EPA Region 6 Sanitary Survey Form System Information and Contacts

PWSS Number	Water System Name	Date
061020808	Firelake Grand Casino Water System	11/20/13
Basic System Information		
Recommended Certification Level		
ODEQ level 3		
System Classification (C-NTNC-NC)	Service Area Type Code	Seasonal (Y/N) Seasonal Begin Date Seasonal End Date
C	R	N N/A N/A
Legal Entity	Name	Address Phone Number Legal Entity Code
Administrative Contact	Richard Kunze Public Works Director	1601 South Gordon Cooper Dr. Shawnee, OK 74801 404-275-3121 AC
Operator in Responsible Charge	Keith Jennings Manager	777 Grand Casino Blvd Shawnee, OK 74804 405-248-0993 DO
Utility Director		
Operator	See List on next page	
Names of Sanitary Survey Inspectors	José G. Rodriguez, US EPA Region 6 Bill Davis, Bill Davis Consulting	
Name of Operators Present	Keith Jennings

Firelake Grand Casino Water System Findings

South Well with Geothermal pond in background and showing casing height

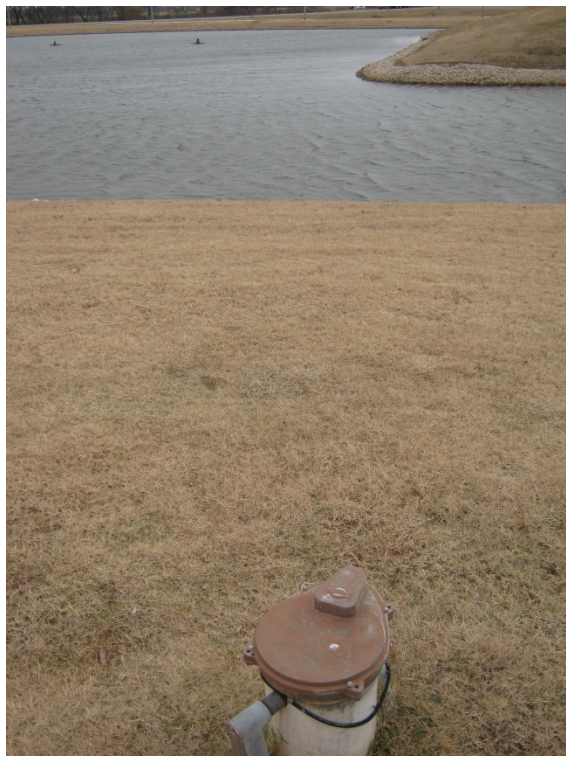
* There is a gap in the well where a rope enters the well casing, compromising the sanitary seal.

** The well is located about 20 feet from a roadway and about 100' from a pond used for geothermal cooling/heating.

There is a gap in the well head where a rope enters the casing. This compromises the sanitary seal.
	The well casing and vent do not extend at least 18" above the ground
North Well	The well has no flow meter, pressure gauge, blow off, raw water sample tap or check valve.
	There is an abandoned well within 20' of the north well (said to be only 1 or 2 feet deep)
	The well casing and vent do not extend at least 18" above the ground
	There are openings in both of the electrical conduits going into the well.
Well 3	The well vent is not 18" above the ground, is not turned over and does not have a 24 mesh screen.
	The well 3 pad does not extend 3 feet from the well casing in all directions.
	Well 3 does not have a blow off
	There is a gap where the electrical conduit is connected to the well casing cap that compromises the sanitary seal.
Well 4	The concrete pad at well 4 does not extend 3 feet in all
